Access Compliance Report

Public Rights-of-Way

Intersection ID: N/A	Main Street: BRECKFIELD_CT	Cross Street: HALKIRK_MANOR_LN	Location: NE
ADA ID: 5CAE0B9D6602	Ramp Type: PerpDiag	Initial Pass/Fail: Fail	Overall Compliance: No
		Severity Score: 25

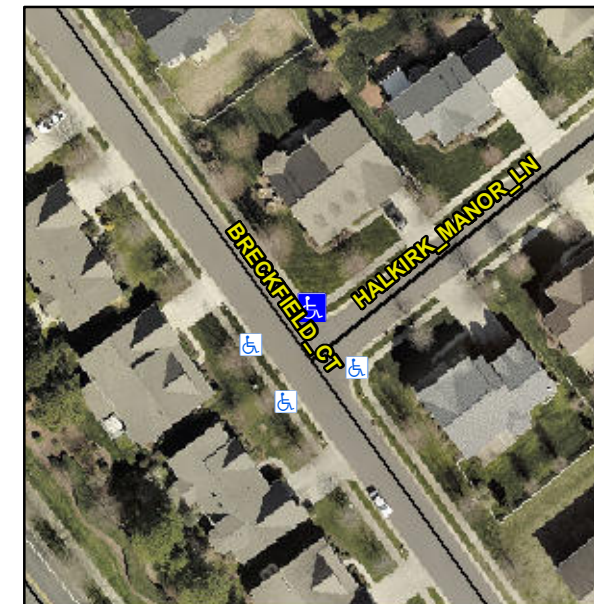
R304.2.2, R304.5.3

Compliance	Description	Data	Compliance	Description	Data
N/A	Ramp Length (in)	48.0	No	Ramp Slope (%)	8.7
Yes	Ramp Width (in)	48.0	No	Ramp XSlope (%)	5.2
N/A	Flare Type LT	N/A	N/A	Flare Type RT	N/A
N/A	Flare Slope LT (%)	N/A	N/A	Flare Slope RT (%)	N/A
N/A	Flare Traversable LT?	N/A	N/A	Flare Traversable RT?	N/A
N/A	Landing Length (in)	N/A	N/A	DWS Provided?	N/A
N/A	Landing Width (in)	N/A	N/A	DWS Contrast?	N/A
N/A	Landing Slope (%)	N/A	N/A	DWS Length (in)	N/A
N/A	Landing X Slope (%)	N/A	N/A	DWS Full Width?	N/A
N/A	Landing Curb? (Y/N)	N/A	N/A	DWS Offset (in)	N/A
N/A	Shared Landing?	N/A			
N/A	Gutter Ponding?	N/A	N/A	Gutter Slope (%)	N/A
N/A	Gutter Lip Ht (in)	N/A	N/A	Gutter X Slope (%)	N/A
N/A	Painted X Walk1?	No	N/A	Painted X Walk2?	No
	X Walk 1 Direction	To SW		X Walk 2 Direction	To SE
N/A	X Walk 1 Width (in)	N/A	N/A	X Walk 2 Width (in)	N/A
	X Walk 1 Slope (%)	0.7		X Walk 2 Slope (%)	2.0
	X Walk 1 X Slope (%)	1.5		X Walk 2 X Slope (%)	4.5

Remove & Replace Curb Ramp With Two New Directional Ramps or Equivalent.
